E8362C-03 <u>S E R V I C E N O T E</u>

E8362C PNA Microwave Network Analyzers

An enhancement added to absorb vibration when opening the swing deck during hardware repair.

Figure 1

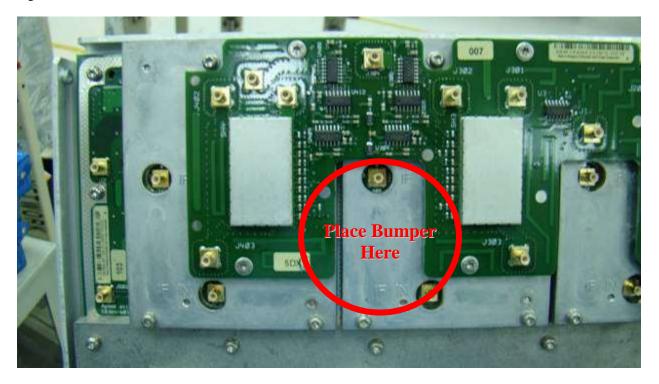
A rubber bumper – E8361-40001 is available to improve the serviceability of the instrument. This will also ensure the swing deck well separated from other nearby assembly.

- 1. Go to http://na.tm.agilent.com/pna/documents.html.
- 2. Click on the appropriate Service Guide.
- 3. When the PDF of the Service Guide is displayed, look at the bookmarks in the left column. Expand the Contents section by clicking on the plus sign next to its bookmark.
- 4. Scroll through the Contents section bookmarks to locate "Repair & Replacement Procedures."
- 5. Click on the title/hyperlink for the section "Receiver Deck."
- 6. Follow the instructions in the subsection "Raising and Lowering the Receiver Deck."
- 7. Once the Receiver Deck has been lower, installed the Bumper as shown in Figure 2.
